OBJECTION

Cree Valley Community Council

Glenvernoch Windfarm

ECU Ref. ECU00004892

Figure 1 – Southern Upland Way Superimposed on GWFA Figure 6.9: Other Wind Farms within 35km Study Area

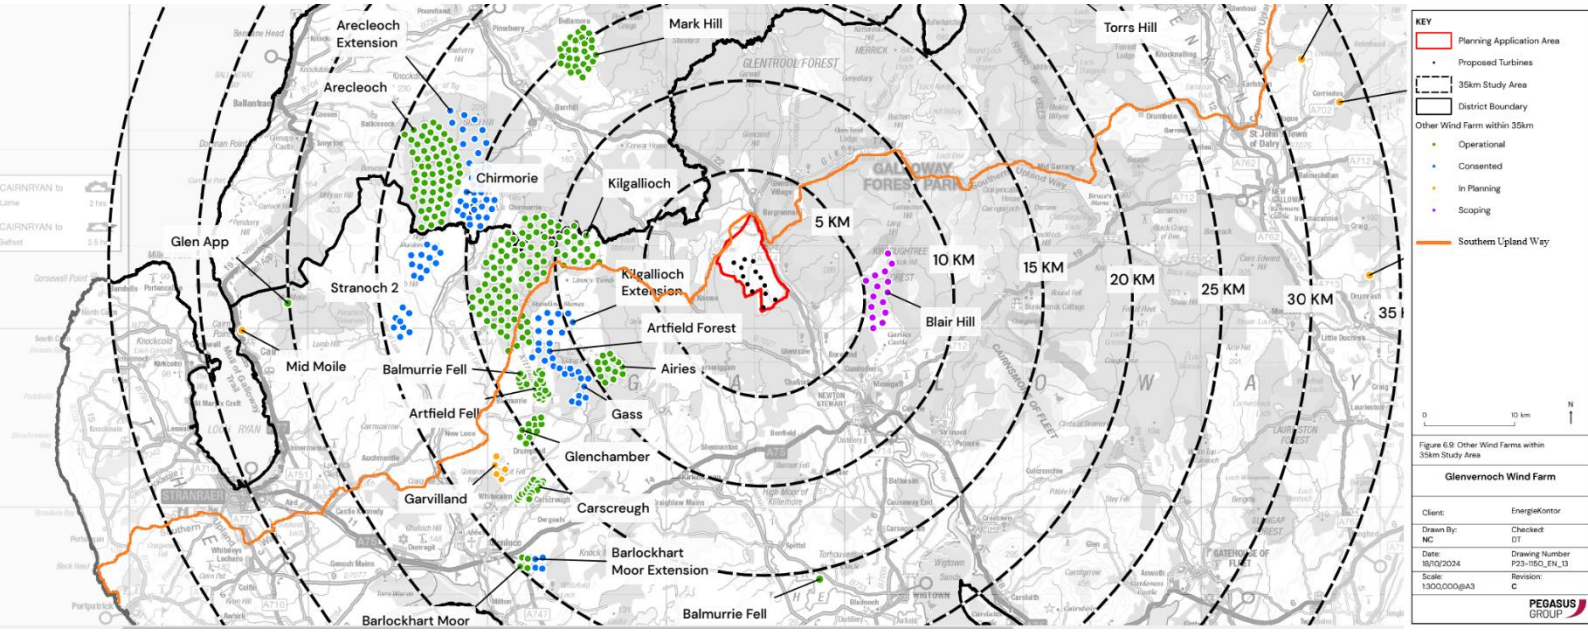
The Southern Upland Way was Britains first official coast to coast path. At 212 miles long it is Scotlands longest walking route. It is an important national asset that passes through the GWFA site on its way east from Portpatrick to Cockburnspath. The section of the SUW running from Castle Kennedy to Bargrennan Bridge, (immediately adjacent to the GWF) will be significantly impacted if the GWF, is consented. This significant impact will be a cumulative visual impact; the direct consequence of the significant increase in the distance, and length of time that anyone going along the SUW will find themselves walking amidst a wind farm rather than walking away from the wind farm behind.

EK have neglected to undertake any sort of rigorous sequential cumulative analysis of the visual experience of walkers as they move along the SUW. Although, the GWFA does provide visualisations that can be interpreted to illustrate the magnitude of the change that will be experienced by a walker heading east along the SUW. Currently in the absence of the GWF, a walker at VP 8 perceives himself to be getting close to escaping the Kilgallioch Wind farm cluster, At VP 7 he is well clear of it and his attention is fully on the Minnigaff Hills looming ahead. At VP 1 the Minnigaff Hills from Cairnsmore in the South to the Merrick in the north fill his view ahead. At VP 4 he is filled with anticipation as to what lies in the forest and hills ahead.

If the GWF is built, the walker will not perceive themselves to be exiting the wind farm until they reach VP 4 at Bargrennan. Instead of the walk from Castle Kennedy consisting of an initial 13km winding towards the uplands and the approaching Kilgallioch wind farm cluster, followed by an 18km wind turbine dominated traverse of the cluster, and a final 12km hike dominated by spectacular views of the hills ahead. Should the GWFA be approved, the walk will simply consist of an initial 13km approach followed by a full 30km walk through a windfarm.

CVCC believe that, if built, the GWF will increase the length of the SUW that is perceived as being within a wind farm by 12km and that it will create a significant cumulative visual impact when all of the existing and consented wind farms along the route are factored in.

Figure 3 – GWFA Figure 7.2 – Heritage Viewpoint Locations

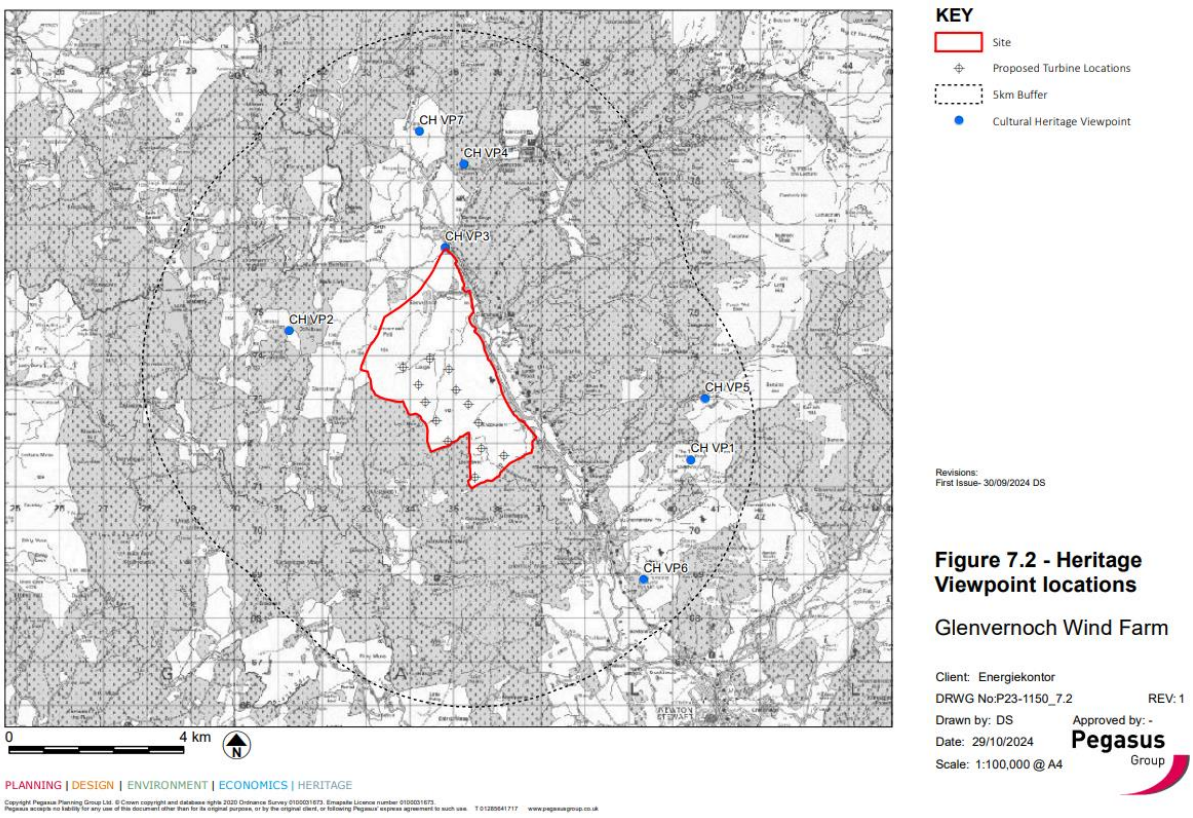
CVCC are concerned that the GWFA will significantly reduce the area of species rich open grazed natural habitat in the Cree Valley. This is illustrated in GWFA Figure 7.2: Heritage Viewpoint locations. The GWFA did not produce Figure 7.2 to illustrate this, but it is useful here because it shows the sheer scale of the coniferous afforestation that now exists around Glenvernoch. The dappled grey area on the map is wooded, almost all of it is commercial conifer plantation with the exception of the Wood of Cree and several other small areas of native or deciduous woodland. The unshaded areas are predominantly open farmland. Until the 1940s, the 350 square kilometres of land surrounding Glenvernoch and lying to the north of Newton Stewart, to the south of Barrhill, and extending from Lamachan in the east to Kilgallioch in the west, was virtually all open farmland. The map in Figure 7.2 does not cover this entire area, but it illustrates the vast extent of the conifer plantations that have since replaced the majority of the species rich acidic grasslands, rush pastures, mires and moorlands and associated small areas of improved productive pasture in fields close by farm steadings.

Glenvernoch, Creebank, and Garchew together with their smaller neighbours extend to form a contiguous area of the habitat described above. It is shown as the central area of Figure 7.2 where it can be seen that it is the only significant area of forest free land, below the tree line, to the north of Newton Stewart. At 2000ha, it appears to be a sizeable area of open natural habitat. It is, but unfortunately, it is all that has survived of what was, until less than a hundred years ago, a continuous open habitat 10 times the size it now is.

If the GWF is built; the 6 miles of unsurfaced roads, the 15ha of concrete and hard standings around the turbine bases, the quarries, the watercourse realignments, and the 10ha vegetation clearance zone around all thirteen turbines will not add up to significant area being lost when compared to an overall area of 2000ha. However, it is not the area lost; it is the amount, rarity and value of habitat that will be lost that is of concern. The size of habitat taken up by the GWF will be more than the 500 ha that it occupies on the map because it involves the introduction of very large wind turbines into an area that has become the only extensive open area of rich upland habitat in MGWW that currently remains wind turbine free.
